BROOKHAVEN NATIONAL LABORATORY  
ASSOCIATED UNIVERSITIES, INC.

July 21, 1983

SUBJECT: Generic Issue, Current Transformer (CT) Protection.

Attachment 2

Figure 1.

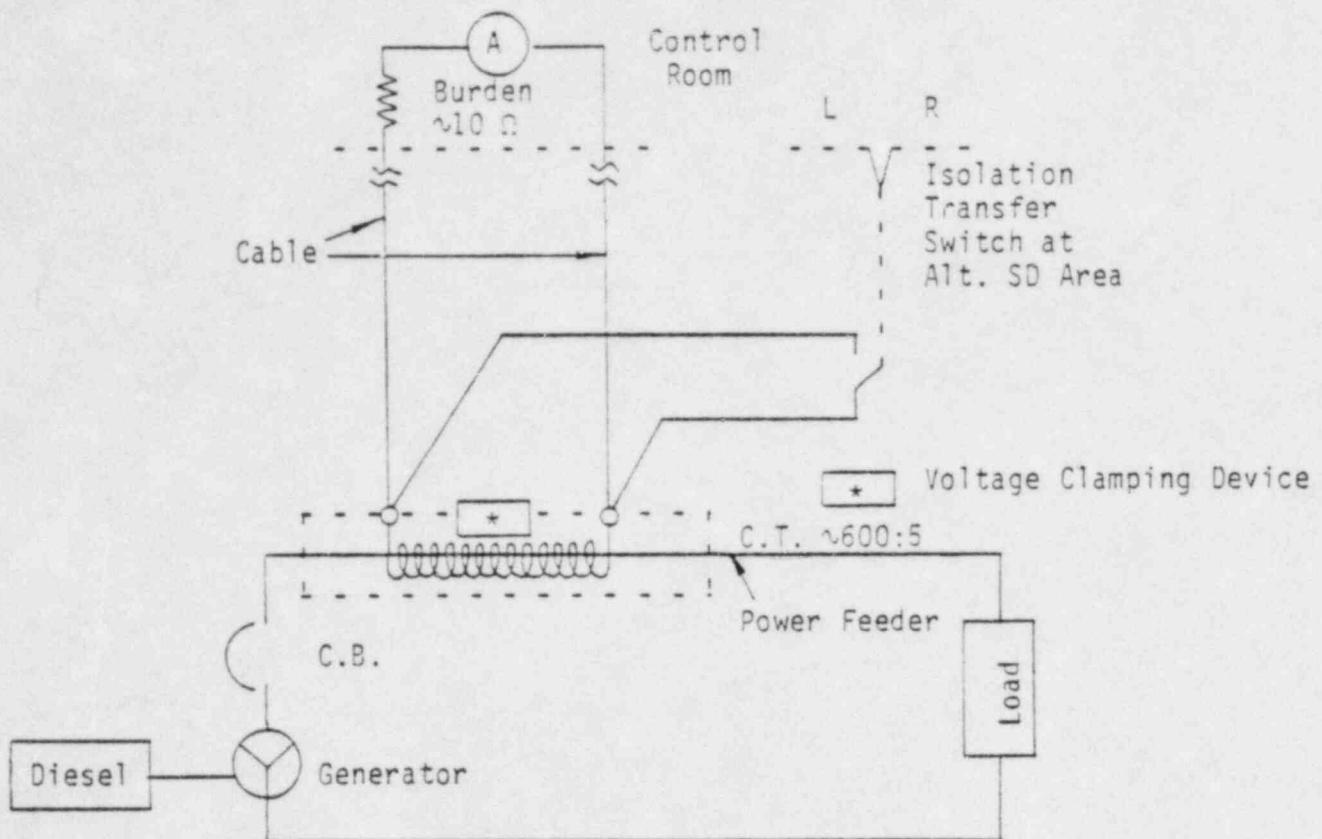
**Problem:** Current Transformer (CT) secondary leads routed in cable through cable spreading room to control room. Fire damage could cause secondary circuit to open and the resulting transient could trip circuit breaker if CT does not first destroy itself. Furthermore, it could destroy breaker contacts and break down power feeder insulation, causing second fire. CT will probably destroy itself sooner or later. All of this could happen before an operator can reach isolation switch whose contact shorts secondary.

**Background:** If diesel generator is loaded to approximately full load (555-600 amps for Oyster Creek), secondary circuit will carry 4.6-5 amps due to law of equal amp-turns. If burden impedance is approximately  $10\Omega$ , maximum secondary voltage will be  $10 \times 5 = 50$  V rms. Given a typical transformer ratio of 600:5 (120:1), the maximum primary (power feeder) voltage due to the transformer is then  $50/120 = 0.42$  V rms

which is negligible compared to generator voltage of 4160 V. However, if the secondary circuit opens, the circuit load can go to  $10^8 \Omega$   $\pm$ , driving the secondary voltage toward  $5 \times 10^8$  V, and the reflected primary voltage toward  $4.2 \times 10^6$  V. This is because primary (power feeder) current still flows. The reflected voltage appears between the power feeder and ground.

**Damage Analysis:** Unless the secondary is shorted within 1 cycle (approximately 16 ms), or unless there exists a voltage clamping device at the secondary terminals, the current transformer will ultimately self-destruct. However, a current transformer for a 4160 V system could have insulation rated for at least 11 kV, and industrial insulation usually has very large safety margins. Thus, it will take a few seconds to be destroyed by short circuit.

With the onset of the transient, the breaker's OV protection circuit starts to act. If this succeeds in tripping the breaker before the CT self-shorts, the breaker contacts will open at the transient voltage level present. This could severely damage or destroy the contact material due to the high voltage arc (the breaker, too, is rated for 4160 V service).

The diesel generator winding and the load will also see the transient, and either or both could be damaged depending upon their sensitivity and the time necessary for breaker trip and/or CT self-short. The isolation switch contact will also see the secondary transient and could break over--ultimate damage unknown.

**Results:** An unclamped or unshorted (external) CT circuit opened by fire damage could cause the following:

1. Self-destruction of the CT--a second fire may be part of this.
2. Destruction of the circuit breaker supplying the generator or other critical load with a resultant loss in that load.

3. Opening of a circuit breaker on a needed power circuit.
4. Power feeder breakdown--possible second fire.
5. Destruction of other sections of the secondary cable (upstream towards the CT) due to voltage breakdown.
